ADMINISTRATIVE AMENDMENT
 File #04-01474 Project # 100046A
 Building replacement with less square footage. See attached letter w/ conditions.
 Approved by: [Signature]
 DATE: 1/28/05

NO.	DATE	REMARKS	BY
REVISIONS			
		PASEO DEL NORTE AND GOLF COURSE WAL-MART NEIGHBORHOOD MARKET #317-00 8511 GOLF COURSE RD. NW	DRAWN BY: rwm
		AMENDED SITE PLAN FOR BUILDING PERMIT	DATE: 12-01-2004
		ALBUQUERQUE NEW MEXICO	2387SPB-11-12-04X
			SHEET # 7 OF 27
			JOB # 230087
ENGINEER'S SEAL		RONALD R. BOHANNAN P.E. #7868

Request: Administrative Amendment to an Approved Site Development Plan for Building Permit for Parcel H-6A1A-1 and H-6A1A-2 Riverview. Total of 6.4955 acres.

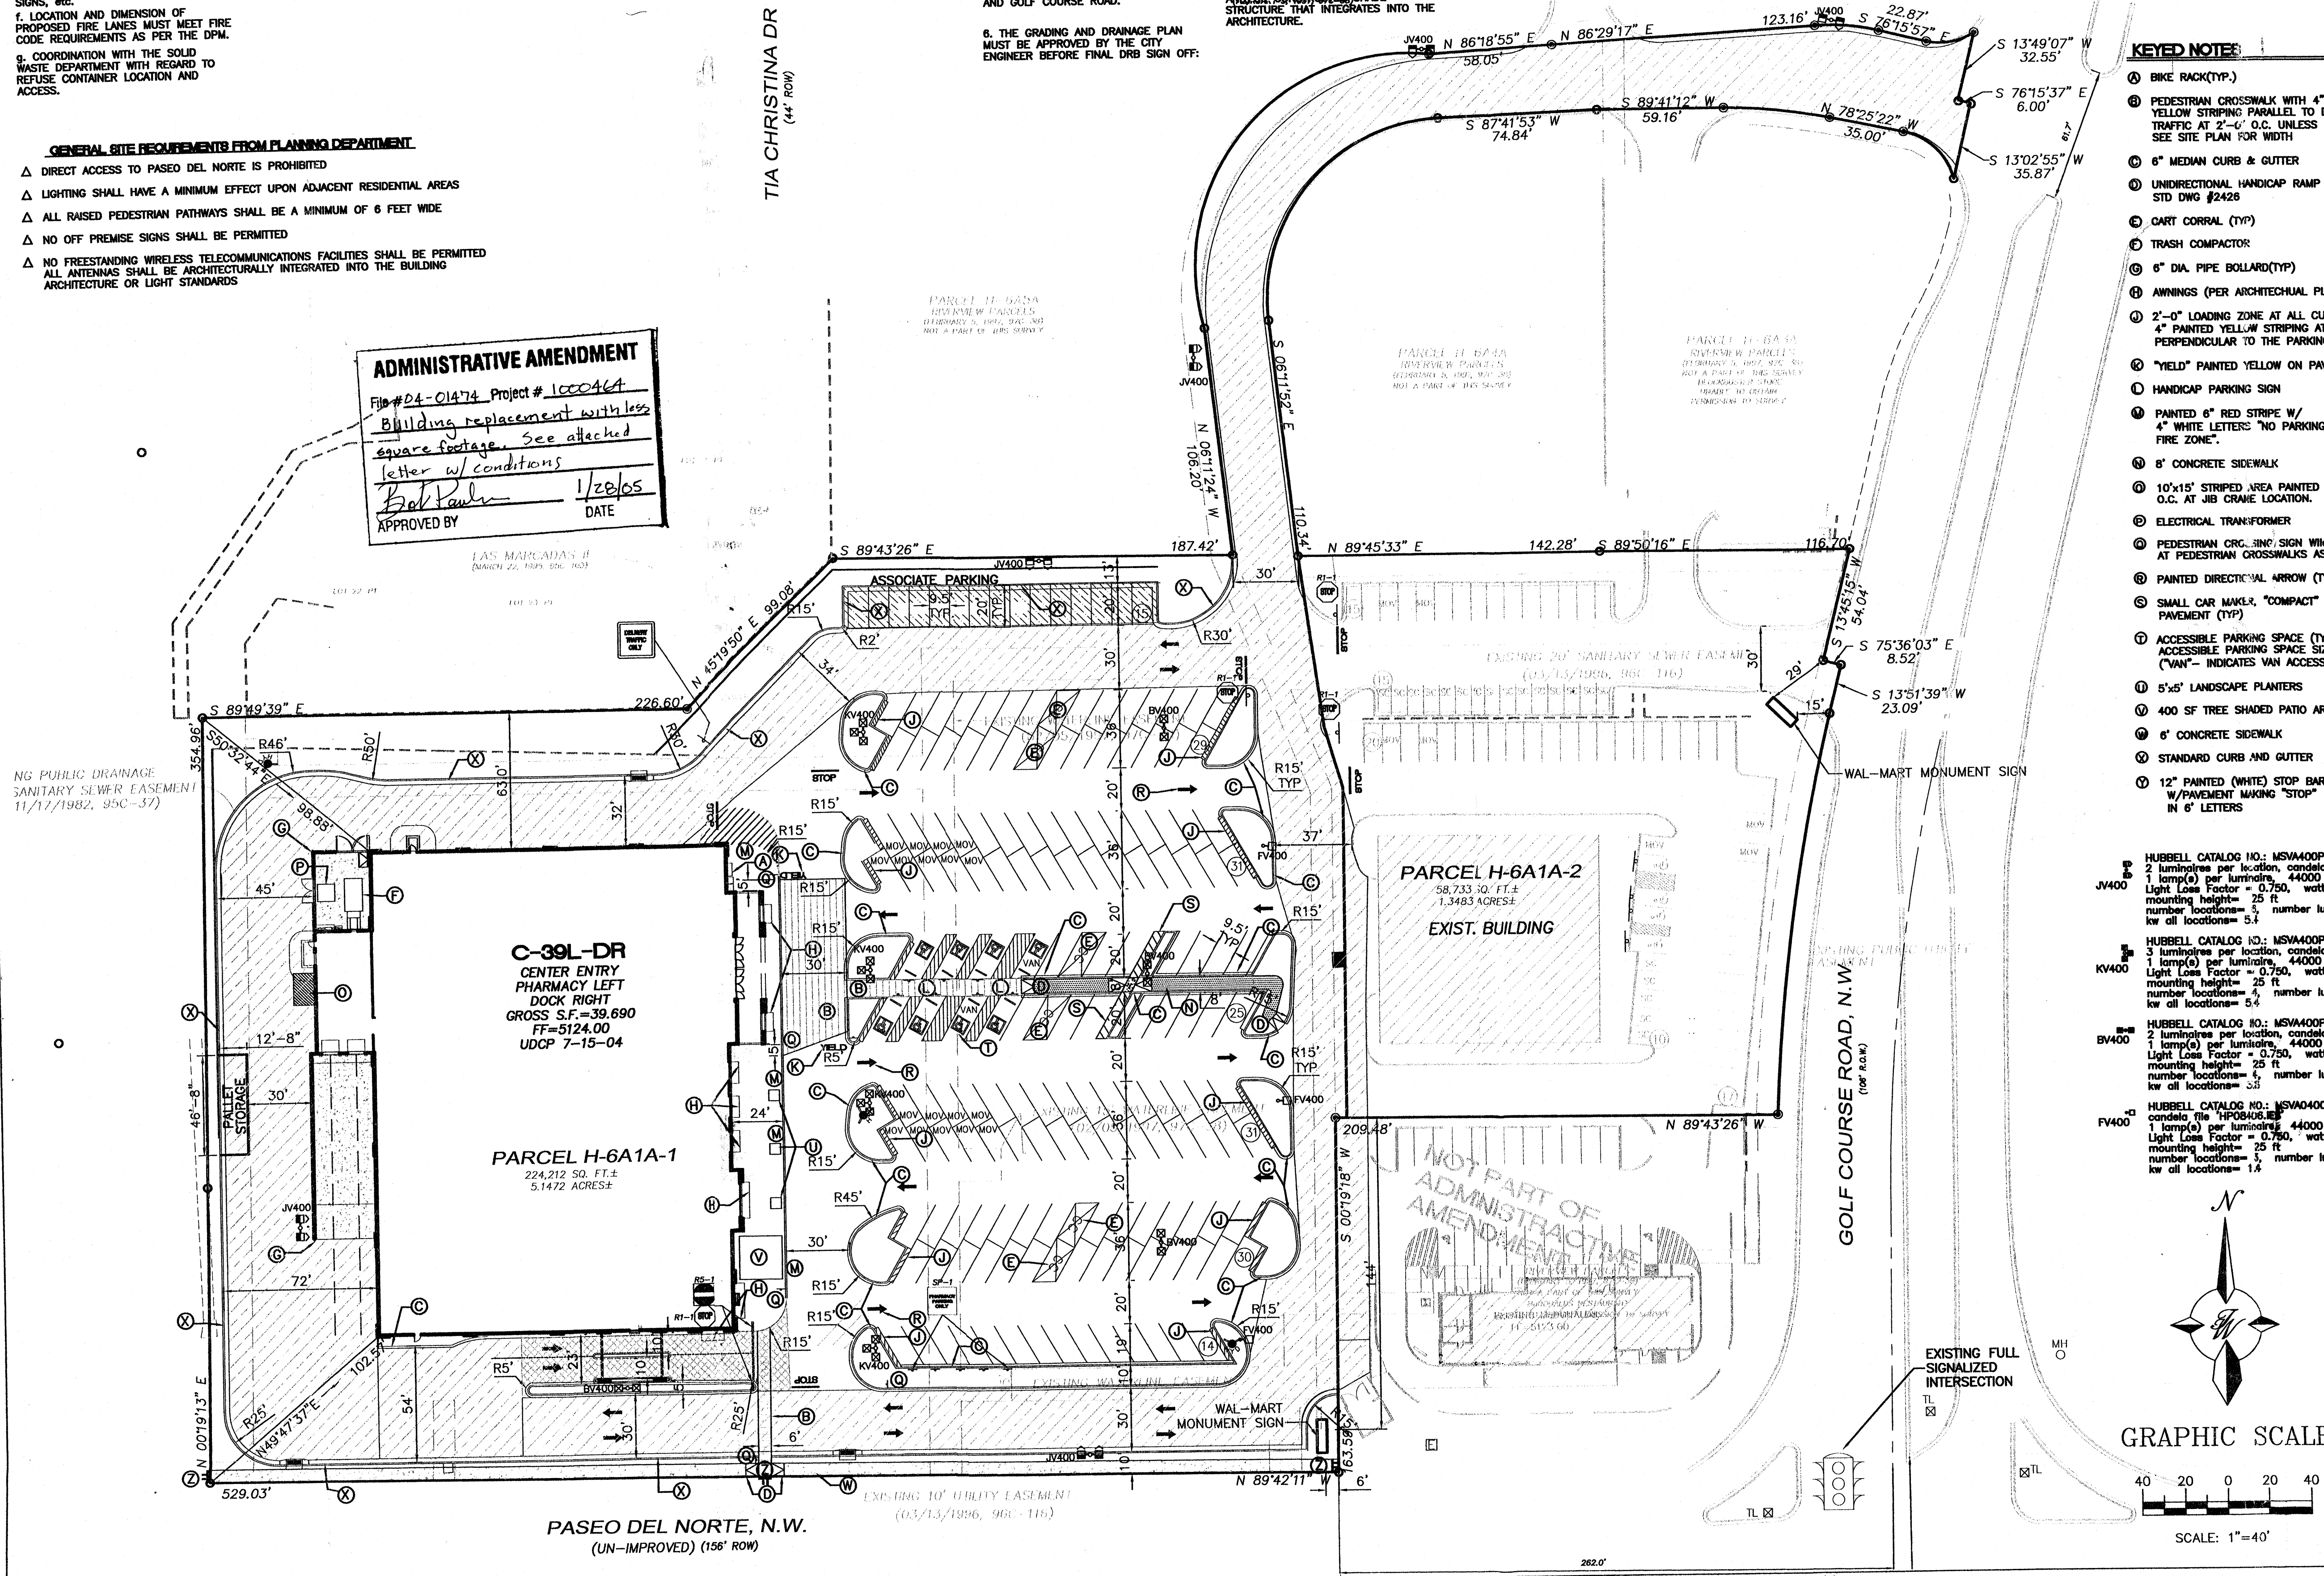
- THE FOLLOWING PUBLIC WORKS CONDITIONS SHALL BE MET BEFORE FINAL DRB SIGN OFF:
 - INCLUSION OF A NOTE ON THE SITE PLAN WHICH STATES THAT DIRECT ACCESS ONTO PASEO DEL NORTE IS PROHIBITED.

- CONSTRUCTION OF REQUIRED PAVEMENT, MEDIAN, CURBS, GUTTERS AND 6 FOOT SIDEWALK ON PASEO DEL NORTE.
 - PROVISION OF A 30 FOOT UNOBSTRUCTED SERVICE DRIVE FOR LARGE VEHICLES, FROM THE STREET ENTRANCE TO LOADING DOCK AREAS. CONSTRUCTION OF 25 FOOT CORNER RADI ARE REQUIRED FOR THE SERVICE ROUTE. A MINIMUM OF A 3 FOOT SETBACK IS REQUIRED TO PROTECT BUILDINGS AND WALLS.

- PROVISION OF ADEQUATE TURNAROUND AREA FOR LARGE VEHICLES ADJACENT TO THE DOCK AREA.
 - THE SITE PLAN MUST IDENTIFY SURROUNDING USES AND PROVIDE DIMENSIONS WHERE APPROPRIATE, I.E. STRUCTURES, STREETS, MEDIANS, DRIVE AISLES, PARKING SPACES, WALLS, SIGNS, ETC.

- LOCATION AND DIMENSION OF PROPOSED FIRE LANES MUST MEET FIRE CODE REQUIREMENTS AS PER THE DPM.
 - COORDINATION WITH THE SOLID WASTE DEPARTMENT WITH REGARD TO REFUSE CONTAINER LOCATION AND ACCESS.

- THE FOLLOWING SITE PLAN CONDITIONS SHALL BE MET BEFORE FINAL DRB SIGN OFF:
 - INDICATION OF THE BOUNDARIES OF THE NORTHWEST MESA ESCARPMENT PLAN IMPACT AREA AND VIEW AREAS OVERLAY ZONES.

- A NOTE WHICH INDICATES THAT LIGHTING SHALL HAVE THE MINIMUM EFFECT UPON ADJACENT RESIDENTIAL AREAS.
 - PROVIDE DIMENSIONS OF ALL MAJOR SITE ELEMENTS, INCLUDING ALL SIDEWALKS AND PEDESTRIAN PATHS.

- REVISION OR ELIMINATION OF PARKING SPACES ON THE WEST SIDE OF THE SITE, BEHIND THE FURR'S SUPERMARKET BUILDING.
 - THE DRIVE AISLE/PARKING/LANDSCAPE CONFIGURATION ON THE SOUTH SIDE OF THE FURR'S SHALL BE REVISD TO AVOID VEHICLE OVERHANG. THE SIDEWALK ALONG THE SOUTH SIDE OF FURR'S SHALL BE A MINIMUM OF 6 FEET WIDE AND SHALL INCLUDE A CONNECTION TO THE TRAIL ALONG PASEO DEL NORTE.

- THE FOLLOWING PEDESTRIAN RELATED CHANGES SHALL BE MADE TO THE SITE PLAN, TO THE SATISFACTION OF THE PLANNING DEPARTMENT, BEFORE FINAL DRB SIGN OFF:
 - PROVISION OF SIDEWALKS TO THE PARKING SPACES ON THE WEST AND SOUTH SIDE OF FURR'S.

- REVISE THE PEDESTRIAN PATH BETWEEN THE FURR'S AND SHOP B TO MAKE IT HANDICAP ACCESSIBLE AND CONSISTENT WITH THE LANDSCAPING PLAN.
 - THERE SHALL BE A MINIMUM 15 FOOT WIDE SIDEWALK AND LANDSCAPE AREA SETBACK FROM THE FRONT FACADE OF THE BUILDING TO THE DRIVE AISLE OR PARKING AREA. THE SIDEWALK SHALL BE SHADED WITH PORTALS, CANOPIES OR SHADE TREES.

- PROVIDE A MINIMUM OF 15 FOOT SIDEWALK AND LANDSCAPE AREA ALONG THE ENTIRE EAST FRONT OF FURR'S. THE SIDEWALK SHALL BE SHADED WITH PORTALS, CANOPIES OR SHADE TREES AT 20 TO 30 FEET ON CENTER IN 5 FOOT BY 5 FOOT PLANTERS.

- NO FREESTANDING WIRELESS TELECOMMUNICATIONS FACILITIES SHALL BE PERMITTED; ALL ANTENNAS SHALL BE ARCHITECTURALLY INTEGRATED INTO THE BUILDING ARCHITECTURE OR LIGHT STANDARDS.

- OUTDOOR PATIO SPACE SHALL BE PROVIDED WITH ADEQUATE SHADING PROVIDED BY TREES AND/OR CONSTRUCTED SHADE STRUCTURE. A PATIO WHICH IS A MINIMUM OF 400 SQUARE FEET IN SIZE SHALL BE PROVIDED ON THE FURR'S PAD, AND A PATIO WHICH IS A MINIMUM OF 200 SQUARE FEET SHALL BE PROVIDED ON PAD B. THE PATIO SHALL HAVE ADEQUATE SHADING PROVIDED BY TREES AND/OR CONSTRUCTED SHADE STRUCTURE THAT INTEGRATES INTO THE ARCHITECTURE.

- THIS IS A DESIGNATED SHOPPING CENTER SITE, THEREFORE OFF-PREMISE SIGNS SHALL NOT BE PERMITTED.
 - THE FUTURE TRAIL EXTENSION SHOWN ALONG THE SOUTHERN BOUNDARY OF THE SITE PLAN AND THE CURBED TRAIL ADJACENT TO THE PIEDRAS MERCADAS ARROYO SHALL BE CONSTRUCTED TO THE SATISFACTION OF THE DRB.

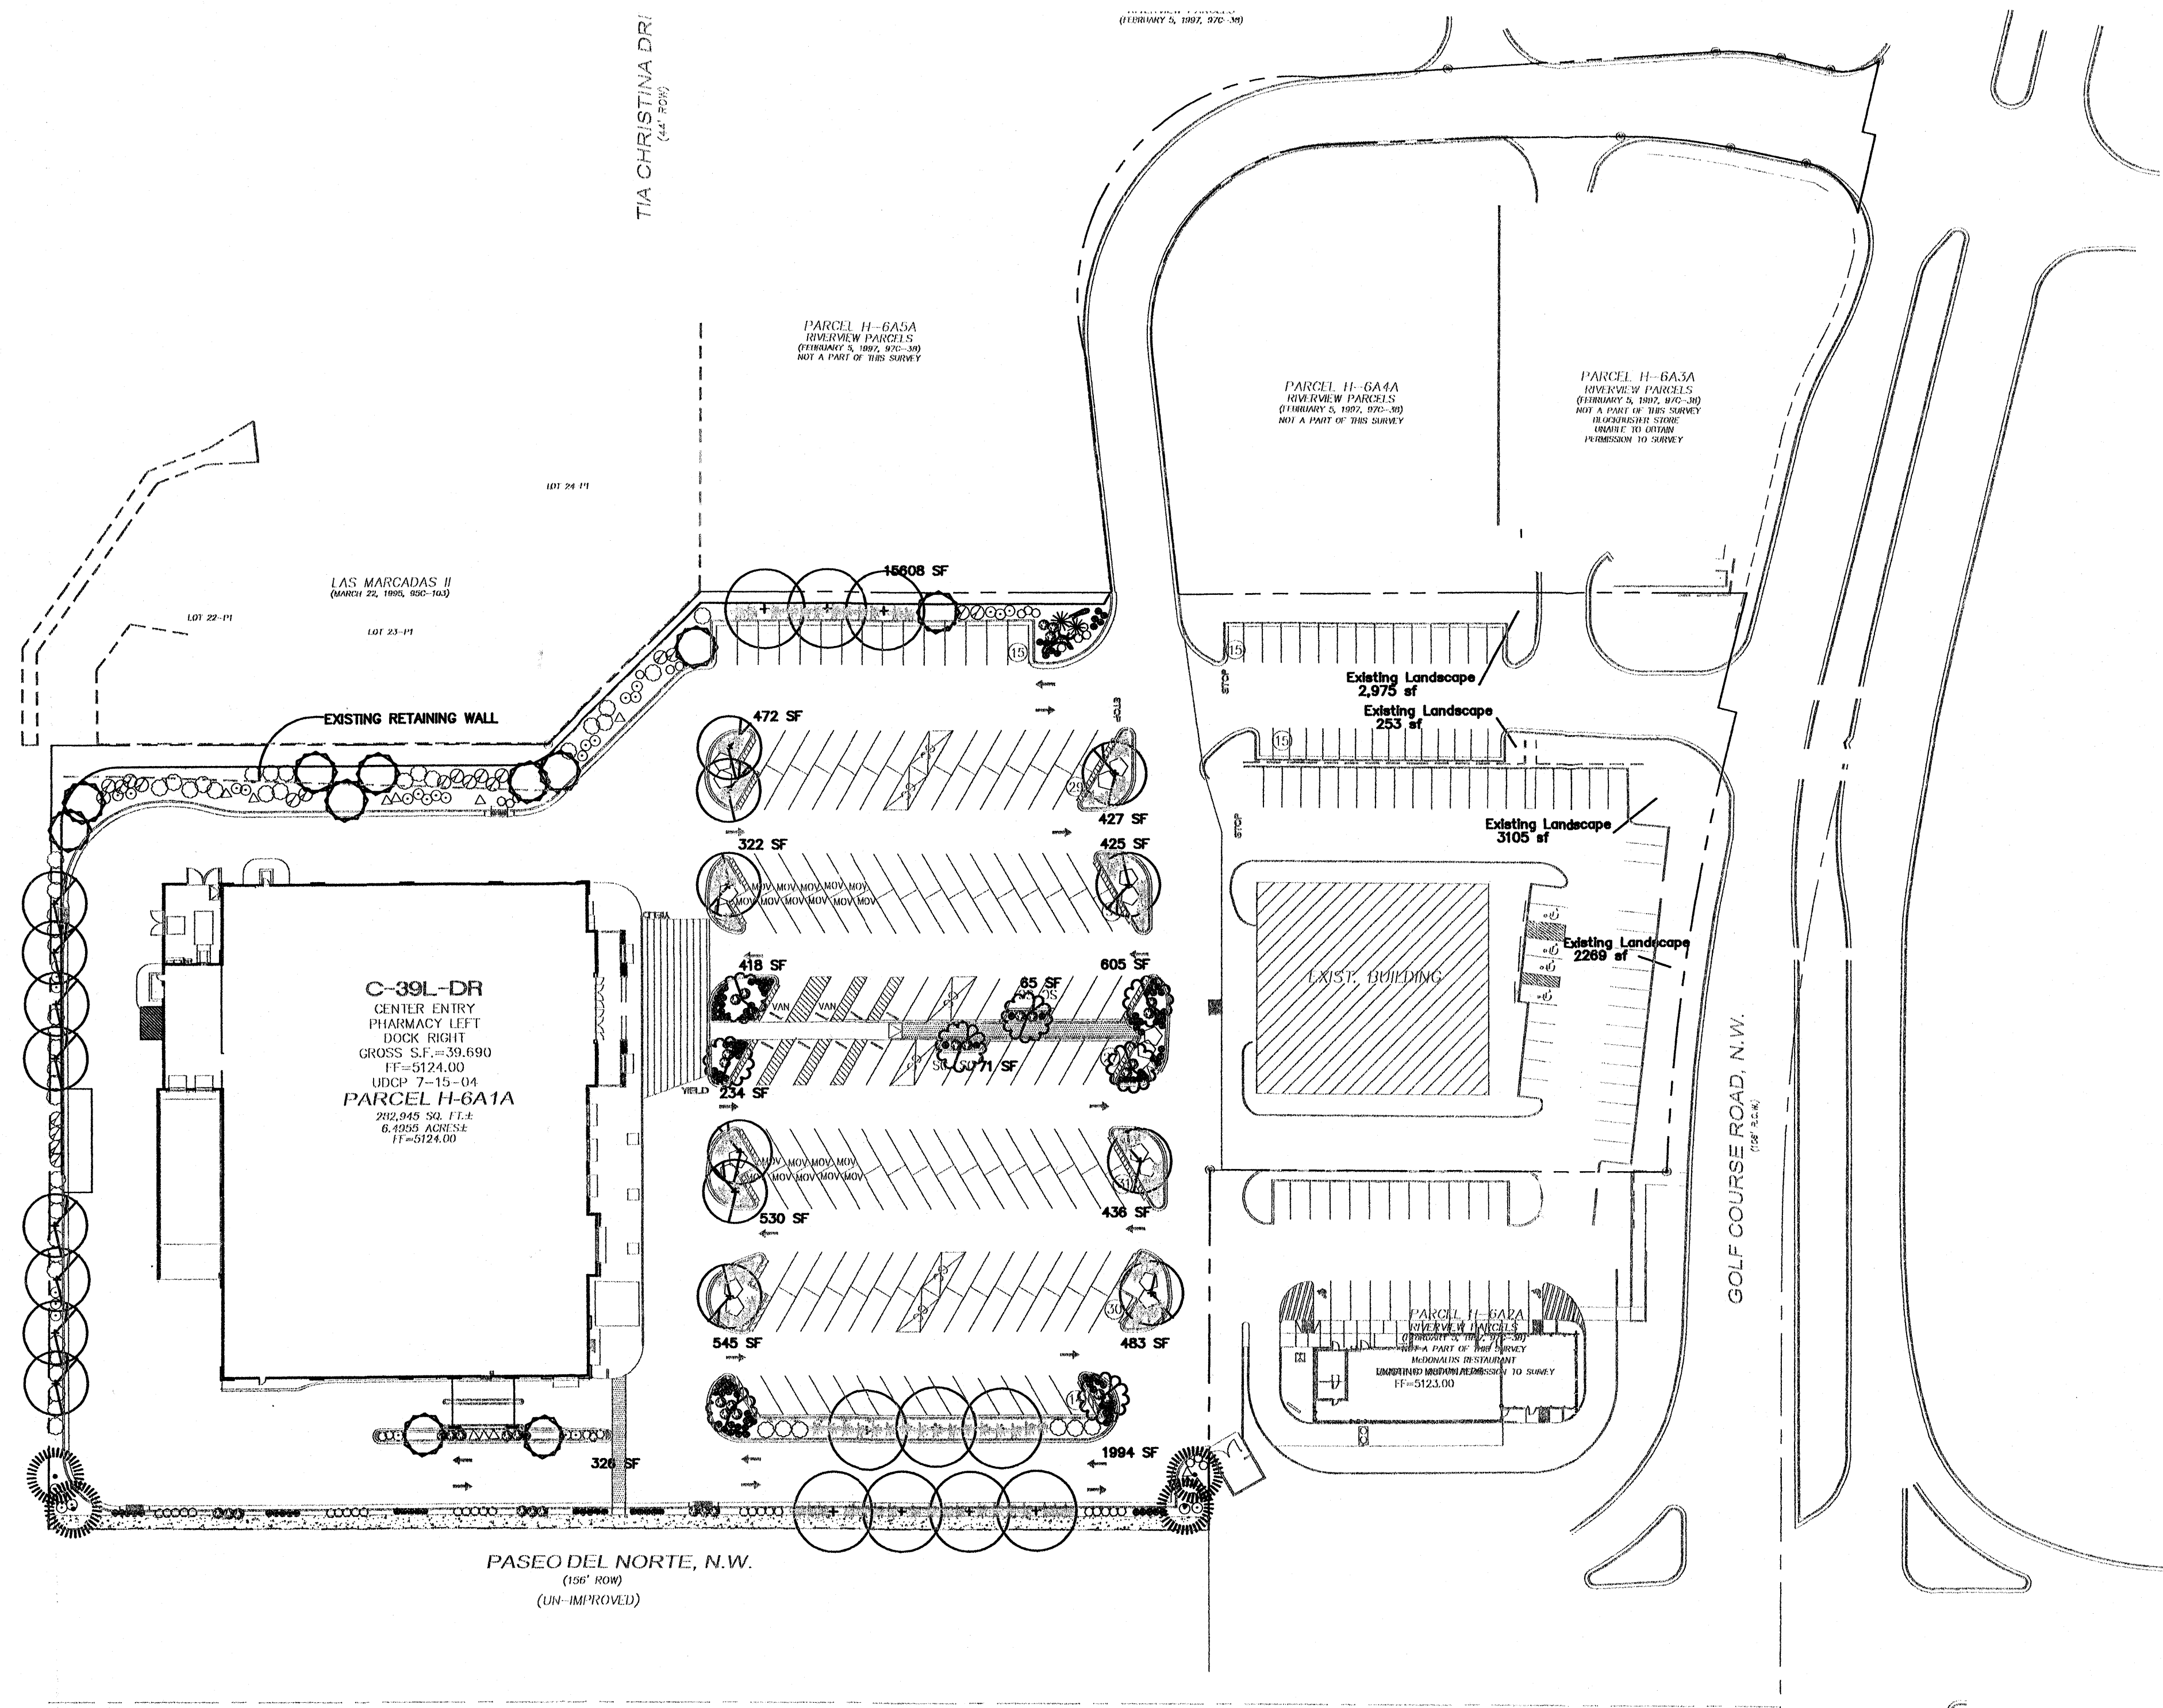
- THE FOLLOWING CHANGES TO THE LANDSCAPING PLAN SHALL BE MADE TO THE SATISFACTION OF THE PLANNING DEPARTMENT, BEFORE FINAL DRB SIGN OFF:
 - PROVISION OF TREES ALONG PASEO DEL NORTE IN COMPLIANCE WITH THE STREET ORDINANCE.

- THE LANDSCAPE BUFFER ALONG THE WEST SIDE, ADJACENT TO THE RESIDENTIAL PROPERTY, SHALL CONSIST PRIMARILY OF TREES AT LEAST EIGHT FEET HIGH AT THE TIME OF PLANTING AND CAPABLE OF REACHING A HEIGHT AT MATURITY OF AT LEAST 25 FEET. SPACING OF THE TREES SHALL BE EQUAL TO 75% OF THE MATURE CANOPY DIAMETER.

- REVISION OF THE LANDSCAPING ON THE PEDESTRIAN PATH BETWEEN FURR'S AND SHOP B SUCH THAT IT IS CONSISTENT WITH THE SITE DEVELOPMENT PLAN AND THAT IT IS HANDICAP ACCESSIBLE.

- THE LANDSCAPING PALATE SHALL BE CONSISTENT WITH THAT OF THE NORTHWEST MESA ESCARPMENT PLAN.
 - PROVISION OF THE STREET TREES/LANDSCAPING IN THE AREAS BETWEEN THE CURB AND THE SIDEWALKS ALONG PASEO DEL NORTE AND GOLF COURSE ROAD.
